# LETTER OF TRANSMITTAL

DATE : <b>January 21, 2016</b>	JOB NO. : <b>23475-015</b>
ATTENTION : <b>Brian Richardson</b>	
RE : <b>River Road Bridge #10</b>	
<b>New Haven, VT</b>	
<b>VTAOT BRF 0183 (1)</b>	
<b>P 802-888-7701</b>	<b>F 802-888-4746</b>

# Submittal Notes Rev #2 (To be used when reviewing shop drawing submittal)

## New Haven – River Road Bridge #10 – Project BRF 0183 (1)

### 10. Reference drawing WW2

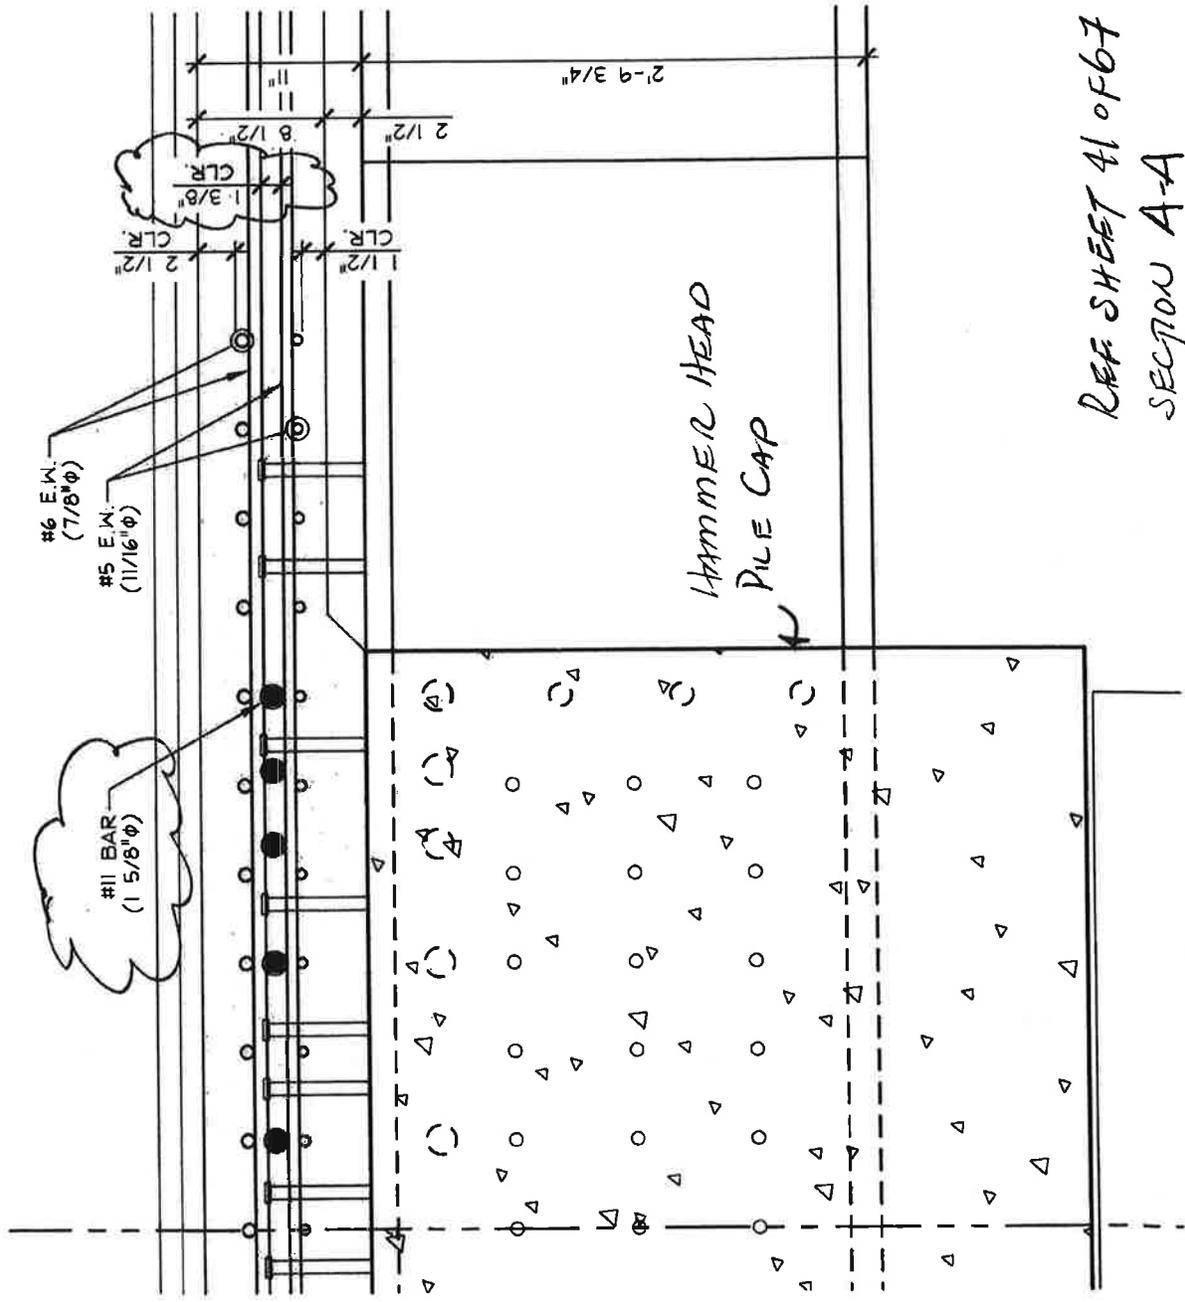
NMB location, see Item #2 and #9

Detail B – surface amplitude, see item #1

Bar above "swift lift" anchor is required by manufacturer.
